**Re: Hydrogeological Re-evaluation Report
Susquehanna River 16" Horizontal Directional Drill Location (S2-0280)
Application No. E67-920 & E22-619
Fairview Township, York County
Lower Swatara Township, Dauphin County**

ATTACHMENT 1
16-INCH HDD PLAN AND PROFILES (AMENDED)

SCALE: 1"=300' DWG. NO: PA-YO-0063.0000-RRa-16

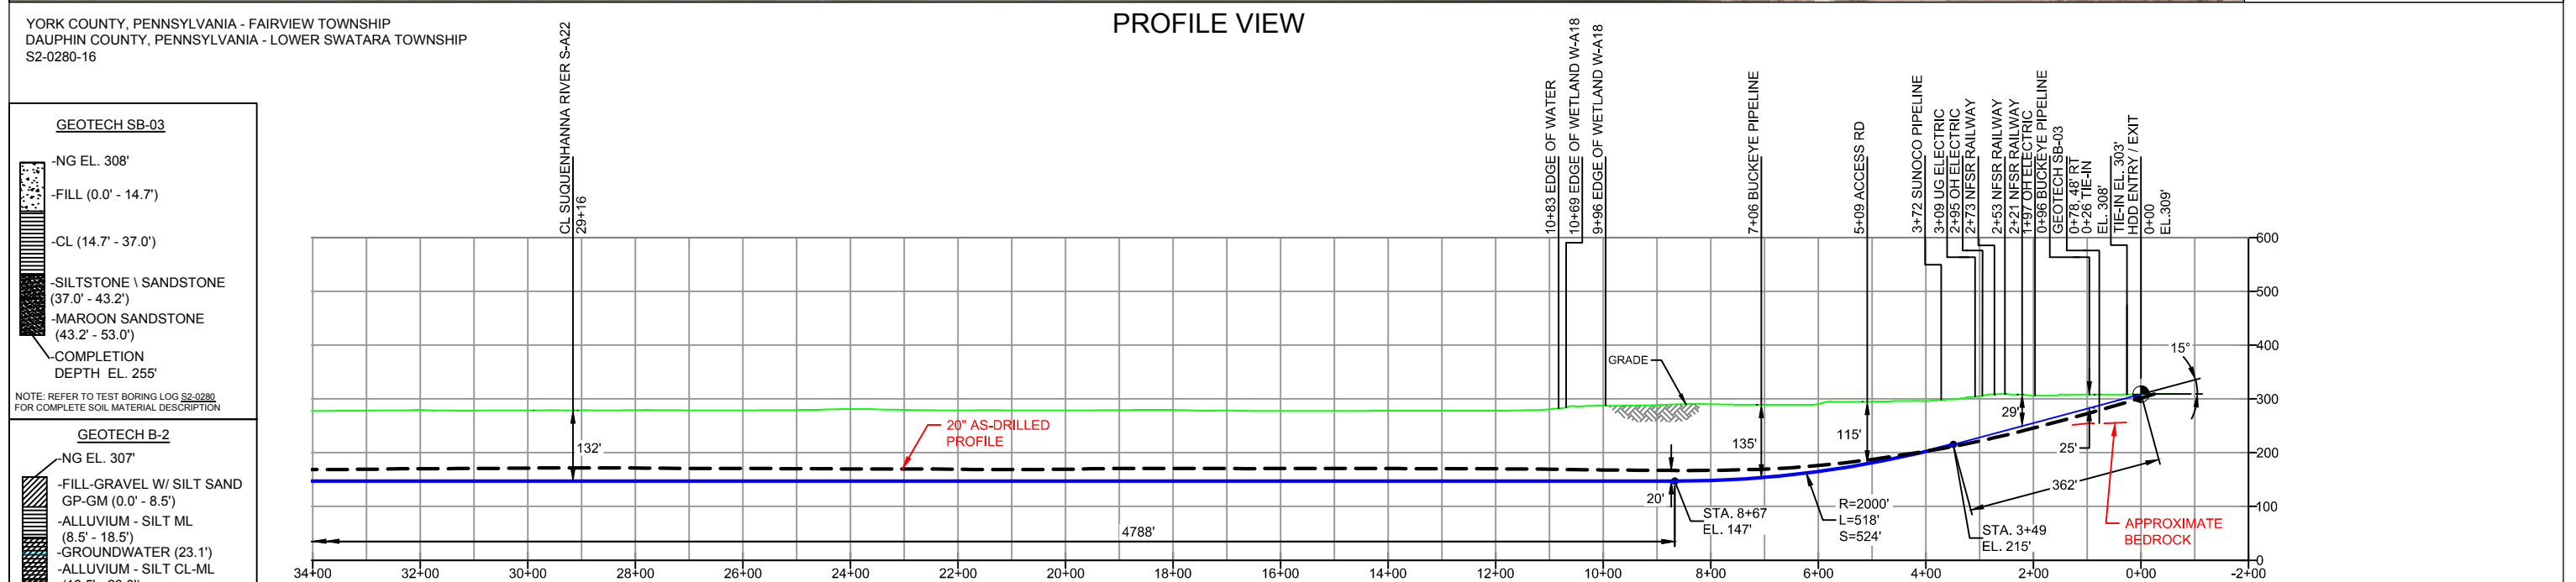
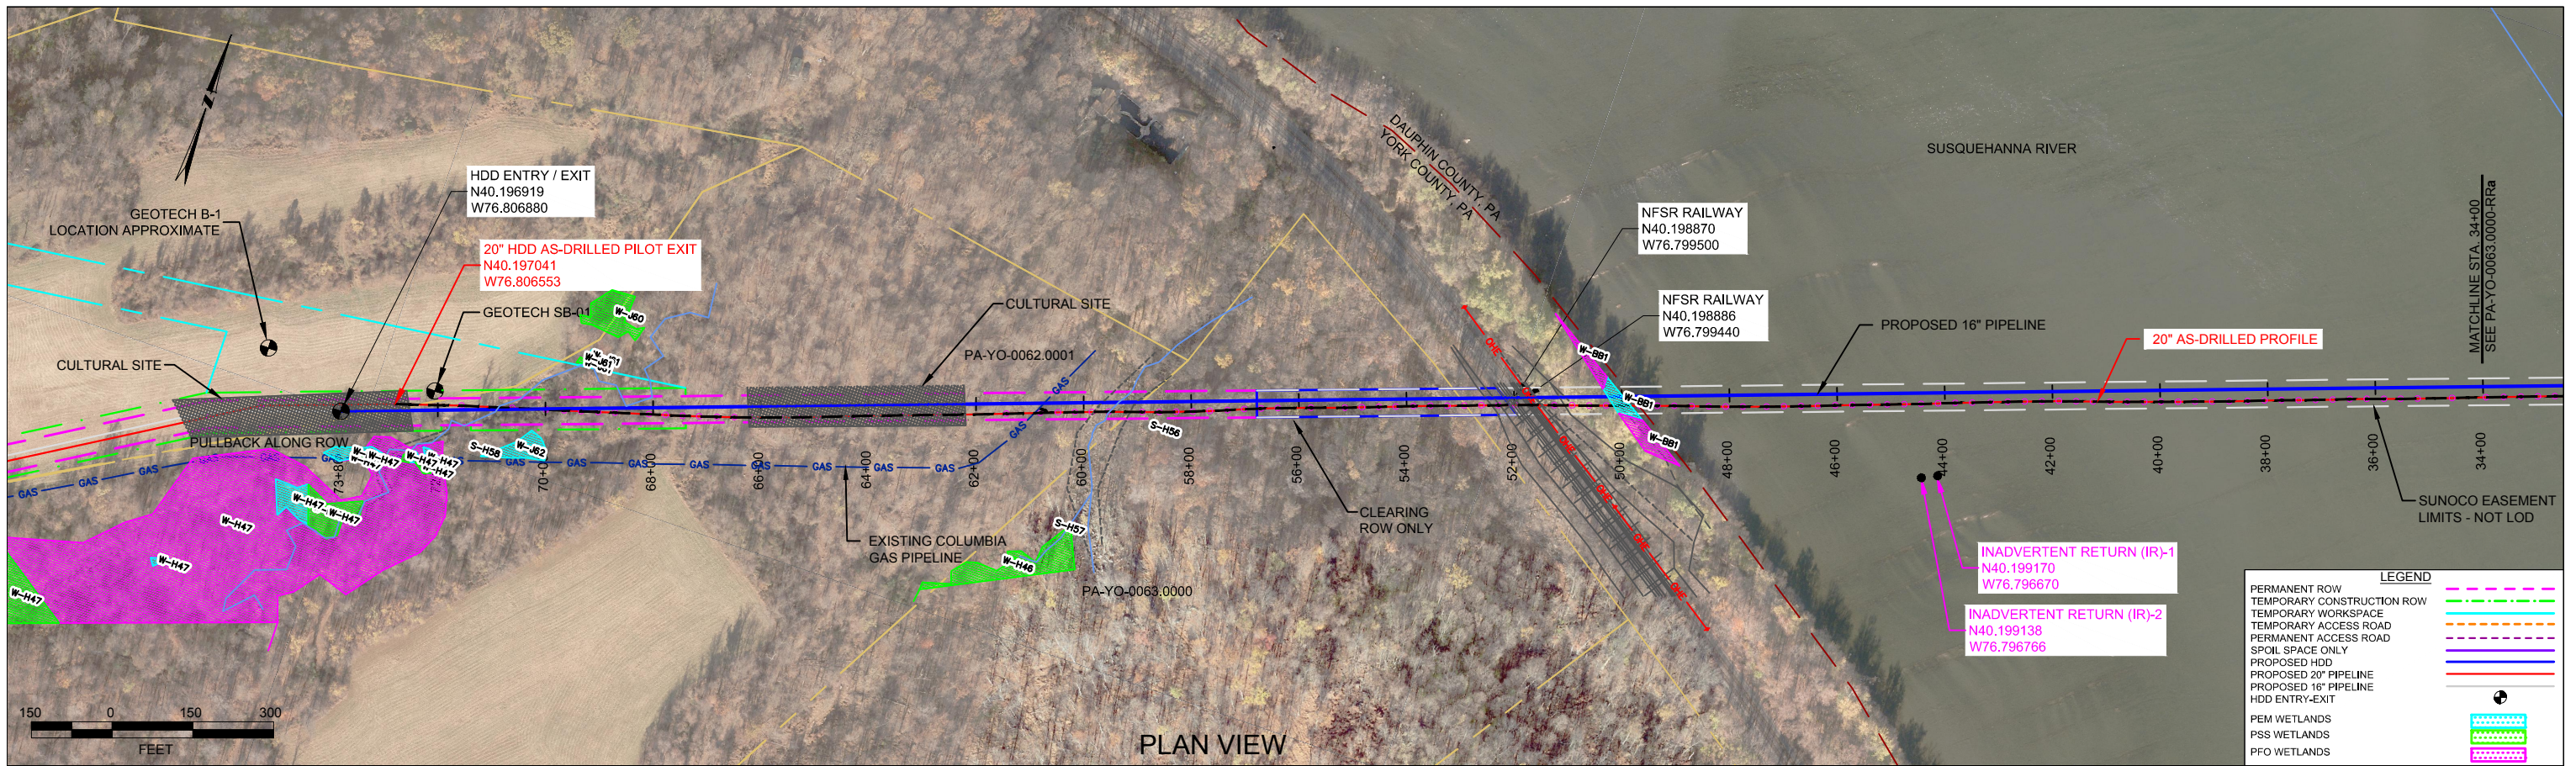
2. The Tetra Tech Geobores B-1 and B-2 of 2017 are not located on Figures 3 and 4 -the cross-section and plan view maps provided in Attachment 2. These borings along with the 2014 borings, SB-01 and SB-03 should be on the plan view maps and the cross-sectional/profile maps. In addition, these maps should also have the boring logs box for Geobores B-1 and B-2 on them.

The cross-section and plan view maps have been revised and are included as Attachment 1 with this letter.
